STAFF RECOMMENDATION

NCPC File No. 6913

NATIONAL NAVAL MEDICAL CENTER CONNECTORS AND COURTYARDS

February 26, 2009

Rendering of Buildings 3 and 5 with new connectors and modified courtyard

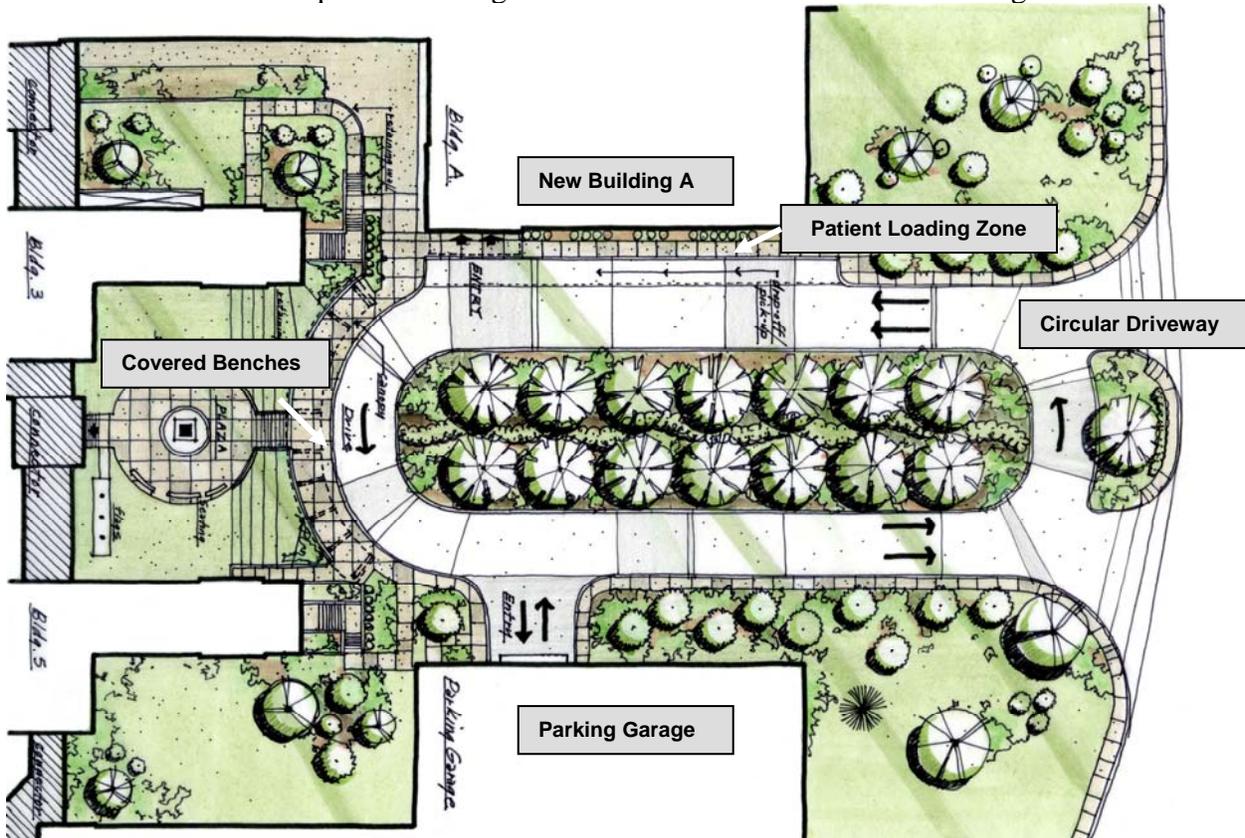
Requests that the Navy submit a modified and more detailed site and landscape plan for the exterior courtyard between Buildings 3 and 5 and the circular driveway. It should consider:

- reducing the size of the circular driveway and increasing the width of the sidewalks;

- creating continuous pedestrian access in front of the garage entrance;
- relocating the covered benches to the entrance of Building A where patients will be dropped off and picked up.

Staff finds that the design of the larger courtyard and circular driveway, in between Buildings 3 and 5, Building A and the patient garage, needs further consideration. Staff is concerned that too much of the space is dedicated to the circular driveway and too little space is dedicated to pedestrians. The sidewalks appear too narrow to adequately accommodate pedestrians and wheelchairs and they abruptly end at the garage entrance. The row of canopied benches also seems misplaced in that they are located away from Building A where passengers will be dropped off and picked up. As a result **staff recommends that the Commission request the applicant submit a modified and more detailed site and landscape plan for the exterior courtyard between Buildings 3 and 5 and the circular driveway.**
